Revision B: This document supersedes previous revisions.

AFTERTREATMENT HYDROCARBON INJECTOR (AHI) – HARD FUEL LINE INSPECTION / REPLACEMENT

THIS SPECIAL BULLETIN CONSTITUTES THE SERVICE CENTER INSPECTION & REPAIR PROCEDURES APPLICABLE TO SAFETY RECALL SR15-04.

FSB 258-020, Aftertreatment Hydrocarbon Doser Fuel Line Change

FIGURE 1
1- Aftertreatment hydrocarbon injector (AHI) hard fuel line
2- Braided section of the hard fuel line

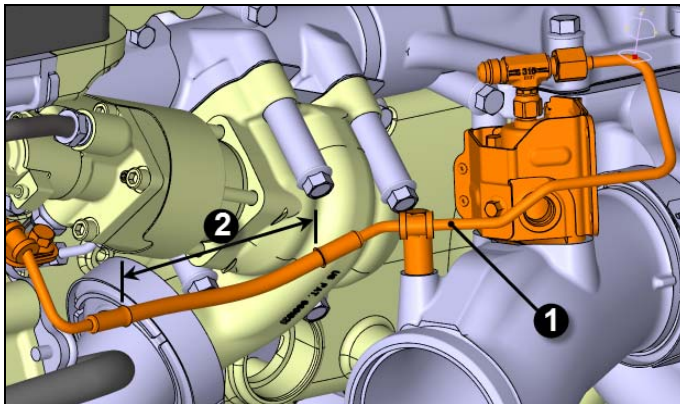
- 1) Locate the braided section of the AHI hard fuel line (item 2, FIGURE 1).
- 2) Check if a double loop nylon tie is installed on the braided section of the injector's hard fuel line (see FIGURE 4 to identify the appropriate type of nylon tie). This can easily be done from behind the coach by visual inspection using a flashlight. This double loop nylon tie should be installed there to maintain the nearby coolant line and the injector's hard fuel line (AHI) together while preventing them from rubbing against each other (see FIGURE 2).

FIGURE 2: PROPER INSTALLATION (seen from above)
1- AHI's hard fuel line
2- Coolant line
3- Double loop nylon tie

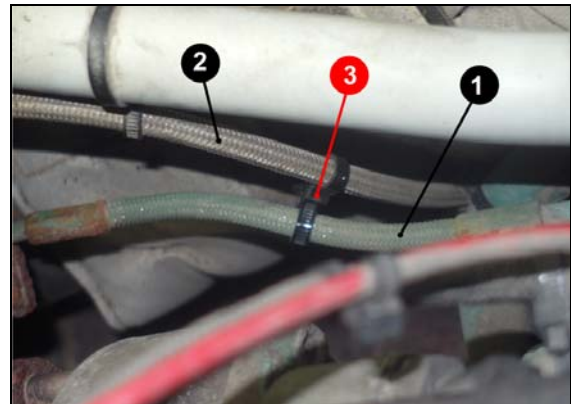
- 3) If the double loop nylon tie is present as shown in FIGURE 2, then the installation is correct. This completes this bulletin, no part replacement is required.

- 1) Service technicians, for the complete procedure, refer to Volvo document **FSB 258-020** available on Impact. **DO NOT FORGET TO INSTALL A DOUBLE LOOP NYLON TIE** as shown on FIGURE 2. Take note that a partial draining of the cooling system is enough while performing the replacement.

FIGURE 3: MISSING DOUBLE LOOP NYLON TIE
1- AHJ's hard fuel line
2- Coolant line

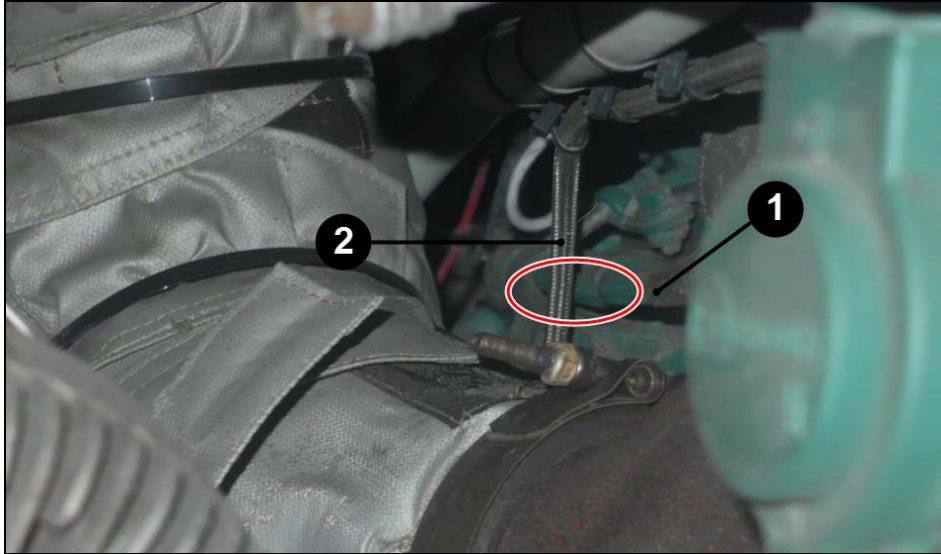
- 4) If, as in FIGURE 3 , **the nylon tie is missing or an inappropriate nylon tie is installed** (standard nylon tie as shown on FIGURE 5), there is a risk that the injector's hard fuel line be damaged by rubbing against the coolant line. The AHI's hard fuel line must be checked and if damaged, it must be replaced.

- 5) If the hard fuel line braided section shows evidence of rubbing and is damaged, then perform replacement as instructed in PART 2 of this document.

W2057937

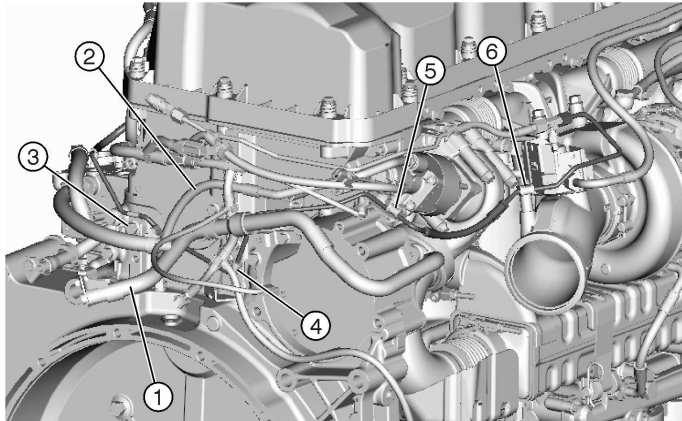
- 15 Position the new hard fuel line (part number 21436788 – B13R, part number 21452506 – Prevost) on the engine.

Do not bend the fuel line during installation.

- 17 Connect the new hard fuel line to the flexible fuel line at the connector near the left rear of the engine.
- 18 Remove old M10 screw and install new screw through the air line bracket and M10 clamp. (Refer to item 3 in figure above)

- Note:** Install all clamps loosely. When all clamps are installed, tighten the fasteners.
- 19 Install silicone clamp on back of engine at the bend of the fuel line. (Refer to item 4 in figure above)

- 20 Install silicone clamp at right side of engine. Confirm that the bend in the fuel line is just outside the edge of the clamp and that the fuel line is not rubbing on the bracket. (Refer to item 5 in figure above)

- 21 Install silicone clamp with spacer and screw to turbocharger diffuser. (Refer to item 6 in figure above)

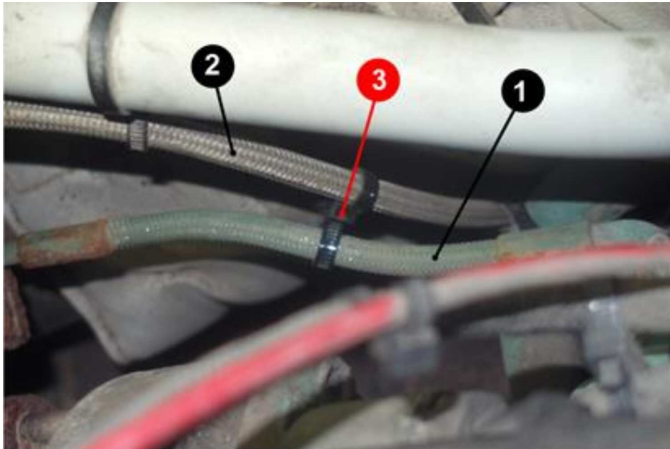
- 22 If vehicle is equipped with Allison transmission, a double loop cable tie must be installed as shown to prevent rubbing between hard fuel line and nearby coolant line.

- 1. Hard Fuel Line
- 2. Coolant Line
- 3. Double Loop Cable Tie
